CITY OF PORTLAND, MAINE

Project Name: 101 York Street Amended Subdivision Plat
Project ID: 2017-084
Address: 85-101 York Street CBLs: 40-C-5
Applicant: 101 York Street, LLC
Planner: Nell Donaldson

Project Name: 101 York Street Mixed Use Development
Project ID: 2015-139
Address: 85-101 York Street CBLs: 40-C-3, 4, 5, 9, 18, 22, 25, 33
Applicant: 101 York Street, LLC
Planner: Nell Donaldson

101 York Street Mixed Use Development
85-101 York Street
Level III Site Plan and Subdivision Review
2015-139
101 York Street, LLC

Figure 6: Approximate areas of increased setback on York Street

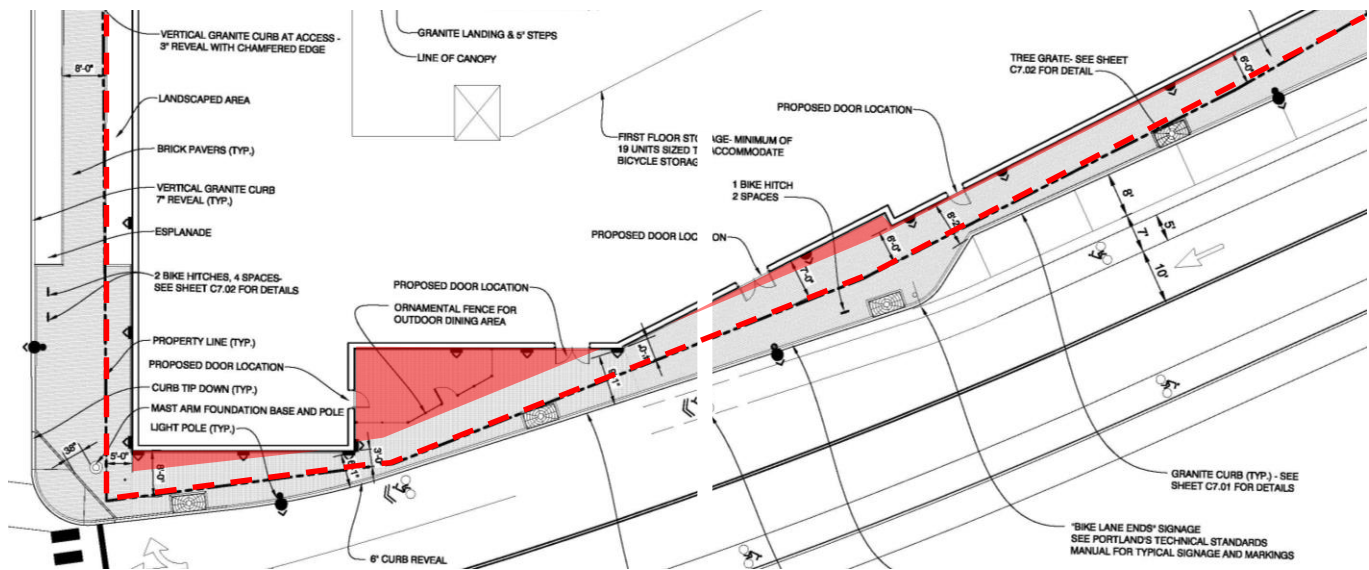
In the final plans, the building continues to exceed the B-3 zone's maximum front yard setback of five feet in several locations. The plans show the point of greatest building setback on the York Street frontage at just over 21 feet (*Figure 6*). In their preliminary submittal, the applicant argued that these setbacks are necessary because of the "unusual geometry of the right-of-way line along the frontage" (*Attachment G*). The applicant has also stated that the increased setbacks will "provide pleasant sidewalk widths while accommodating east-west bike lanes, east-west sidewalks and on-street parking" and provide an "opportunity to support open space amenities such as building entries, outdoor seating, street trees, bike racks, and municipal lighting" (*Attachment U*).

However, it should also be noted that the final plans have removed some pedestrian level details, most notably the sidewalk seat wall and planters, which in the preliminary plans enhanced the streetscape in these areas of increased setback. Staff’s urban design review has questioned the removal of the seating wall (*Attachment 1*). Further, the design review states that “the ornamental fence around [portions of] the proposed additional setback...removes public access to the widened sidewalk. Planning staff recommends a finding that the increased setback provides substantial and viable publicly accessible open space, does not detract from the street wall character, does not create an excessive amount of open space, and provides areas of high quality and character of design, subject to the applicant finalizing the design of the areas of increased setback for review and approval by the city’s urban designer.

The Planning Board approved the additional setback per *Section 14-220(c)* on the condition that the applicant shall provide revised plans including amenities and insuring public access in areas of increased setback for review and approval by the city's urban designer prior to the issuance of a building permit.
